## ANN ARBOR HISTORIC DISTRICT COMMISSION

### Staff Report

**ADDRESS:** 418 S First Street, Application Number HDC11-091

**APPLICATION:** The applicant seeks HDC approval to demolish a one-story garage and construct a two story tandem garage with a studio above.

Topographic map with building footprints (footprints are taken from aerials and are not necessarily to scale)

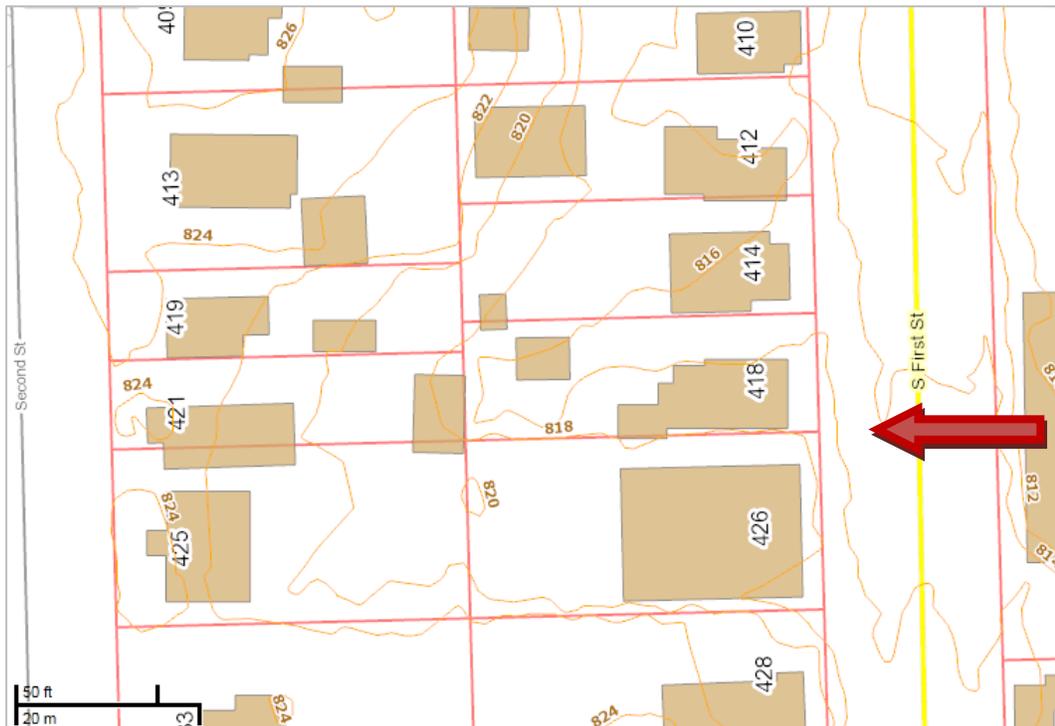
2. This house is situated in a low spot on this block. The houses behind it on Second Street are on ground 8' higher at their front elevations (see topo at end of this report). Surrounding buildings of interest include a large modern apartment building to the south with an entirely paved backyard, a 1 ½ story building near the west (rear) property line that is similar in height to the one proposed in this application, and a large one-story cinderblock building in the backyard two lots to the north that is home to a plumbing and heating company (see area plan submitted with application and aerial photo). Another site consideration is that there are no houses across First Street, only a large lumberyard building that presents a blank wall parallel to the street.
